PCN 6600-5 – Improvement of packaging box

Product Change Notification					PCN 6600-5 - Change in Packaging		
owner	creation date	release date	released by	change order no	rev	page	D10-062-647
joshide	20.01.2022	25.03.2022	blatnma	2023764	A	1 of 2

Current product packaging appearance	New product packaging appearance

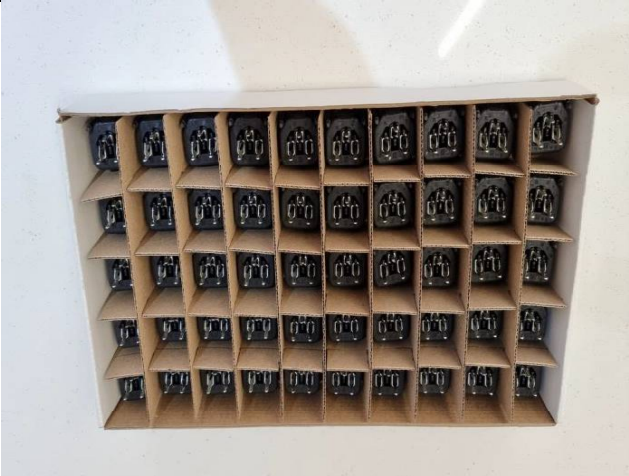
- Improvement of packaging box of Type 6600-5.

Current product packaging dimensions	New product packaging dimensions
L = 360 B = 270 H = 49	L = 380 B = 160 H = 38
